# Embedded Channel Layout Information in 1722a AVTP Frames

Frank Bähren, Intel Corp.

# Proposed Amendment

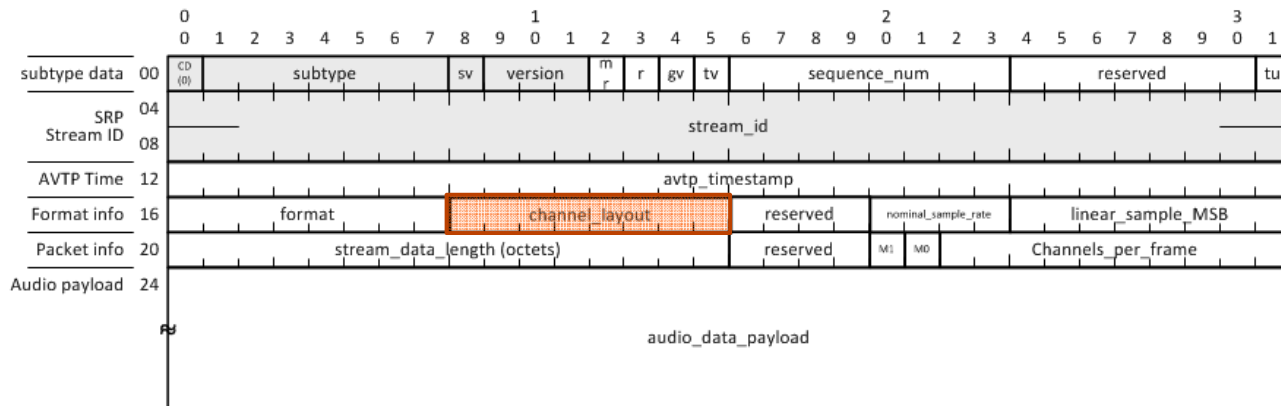
- Even though more than eight speaker locations are defined, no more than eight channels are used in any of the formats
- Some of the eight audio channels remain unused in some of the layouts
- Should these “empty” channels be transmitted at all?

- add reference to CEA-816-E Specification to section 2
- define channel\_layout field using eight of the twelve reserved Format info bits
- create new sub-section 8.2.7 channel\_layout field
  - defines channel\_layout to be coded according to table 28 of the CEA spec
  - defines the behavior with respect to on-the-fly change of layout

# Layouts with less than eight channels (1)

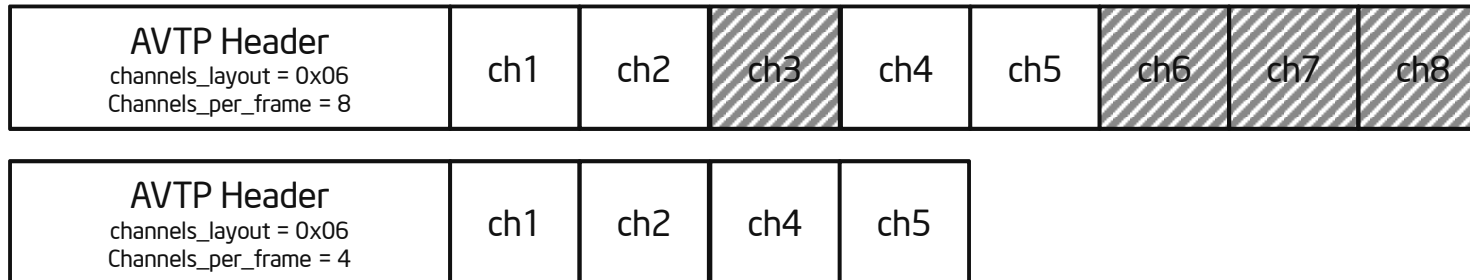
- **Example: Layout 0x06 (Front left/right, rear left/right only)**
  - only four out of eight channels carry data
  - should the other four channels be transported at all?

- **The standard would allow both variants, the simple one and the bandwidth-optimized one**
- **Profiles of industry associations could mandate one form for use in a certain context**
